UNITED STATES PATENT AND TRADEMARK OFFICE

APPLICATION NO.	FILING DATE	FIRST NAMED INVENTOR	ATTORNEY DOCKET NO.	CONFIRMATION NO.
09/875,209	06/04/2001	Neal A. Brown	10431-005001	6091

Office Action Summary

DETAILED ACTION

FIG. 4

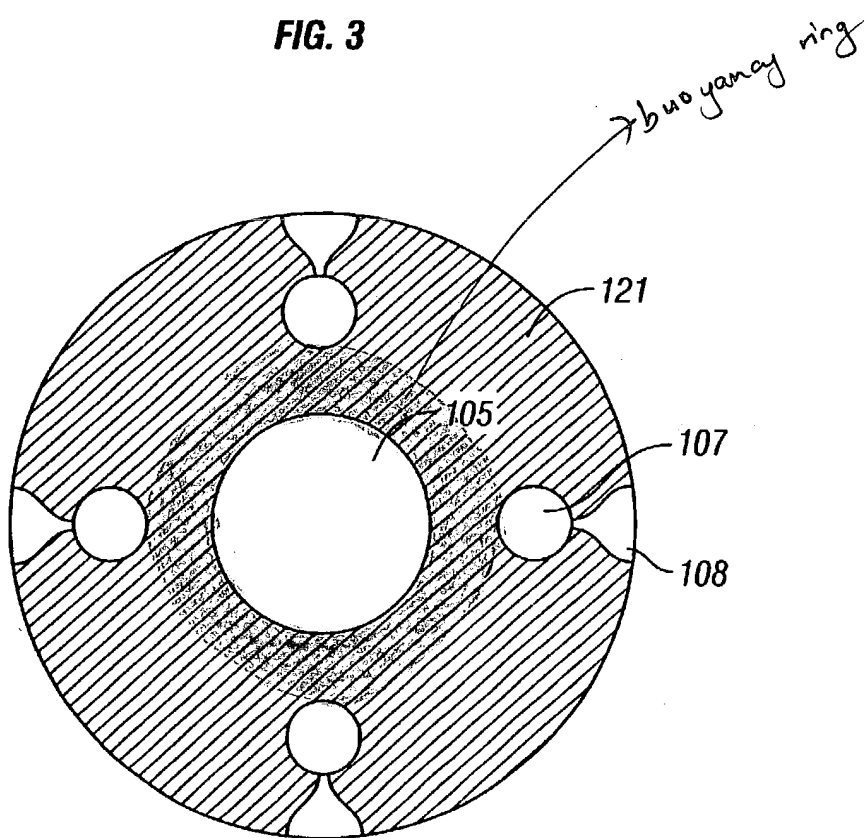
Pollack discloses the invention substantially as claimed. However, Pollack lacks a tail jet/fin and a buoyancy ring disposed between the riser pipe and the annular sheath. Shu et al. teaches tail jet/fin (see Fig. 7, col. 6 lines 13-19) and with regards to the buoyancy ring see attached marked up Figure 4. It would have been considered obvious to one of ordinary skill in the art to modify Pollack to include the tail jet/fin and the buoyancy ring as taught by Shu et al. in order to effectively protect the riser from vortex induced vibrations.
